TRANSPORTATION SAFETY BUREAU OF HUNGARY

FINAL REPORT

2014-093-4P Serious Incident

Airbus A320-232 G-EUUE

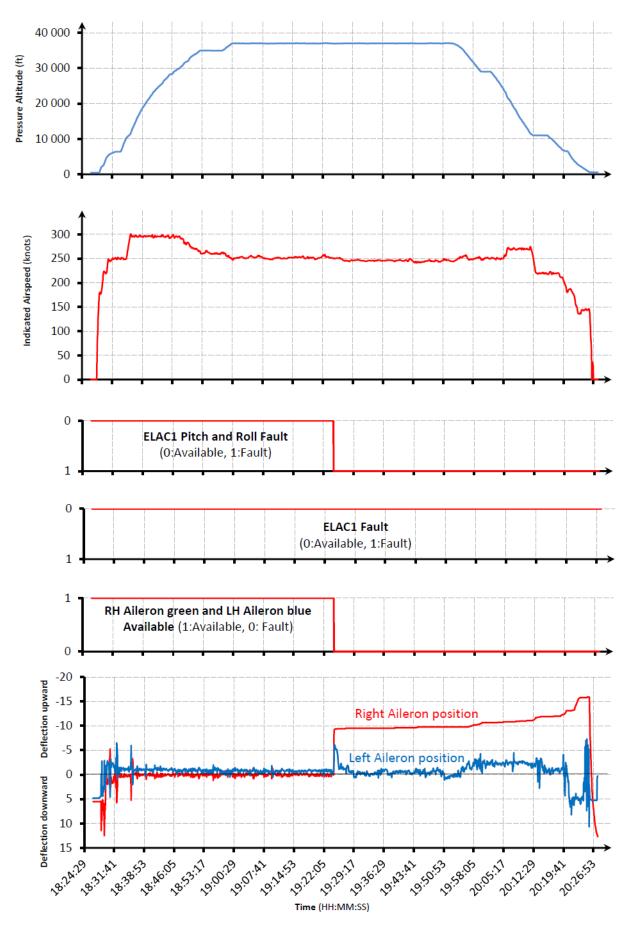
"Based on FDR data, the IC established that, at 19:24:32, malfunction occurred in roll control channel and pitch control channel of the ELAC1, and the green hydraulic system of the right aileron, as well as the blue hydraulic system of the left aileron had been inoperative from the same moment in time; however, according to data from the "ELAC1 Fault" channel, the ELAC1 computer was operative throughout the complete period of flight, and that was the reason why the fault signal on the ELAC1 pushbutton switch did not illuminated. We suggest using the explanation given on the email dated 22 march 2016. "

Reason for comment:

"This paragraph is not totally correct as it suggests that several failures occurred in flight which is not the case. To summarize:

The IC takes the FDR data as evidence, and on the basis of such data, "ELAC1 pitch fault" and "ELAC1 roll fault" occurred during the malfunction (see Figure 5 page 12). The IC does not exclude the malfunction of the Captain Side-Stick during the event under investigation; this is indicated in paragraph 9, page 16 of the Final Report. The e-mail of 22 March 2016 sent by the AIRBUS Factory contained the information that "Shop Findings of the ELAC and Side-Stick are No Fault Found", so the IC has no evidence to establish whether it was the fault of the ELAC1 or the fault of the Captain Side-Stick that actually caused the fault of the right aileron. The fault code from the Post Flight Report reads "ELAC1 OR INPUT OF CAPT ROLL CTL SSTU 4CE1", on the basis of which it cannot be unambiguously proved that any or both of the malfunction acted as the actual fault.

This information has been added to paragraph 8, page 16 of the Final Report.

Figure 7: Position of the ELAC1 pushbutton switch on the Overhead Panel (illustration)

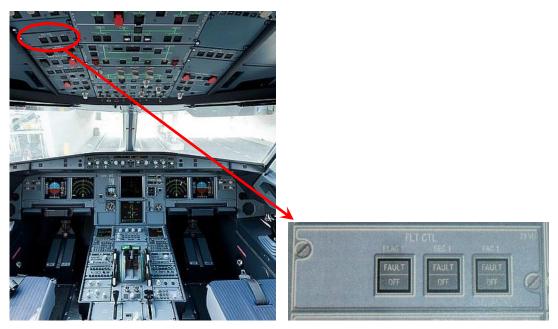
"At 19:24:32, when the airplane was cruising at an altitude of 36 950 ft and speed of 250 knots, the crew perceived the indication "Right Aileron Fault & ELAC1 fault", but The "Fault" light on the "ELAC1 PB Switch" was not Illuminated because the ELAC1 fault was caused by a peripheral system (Captain side-stick) and not the ELAC1 itself . Figure 7 shows the position of the pushbutton switch "

Reason for comment:

Explanation by TSB:
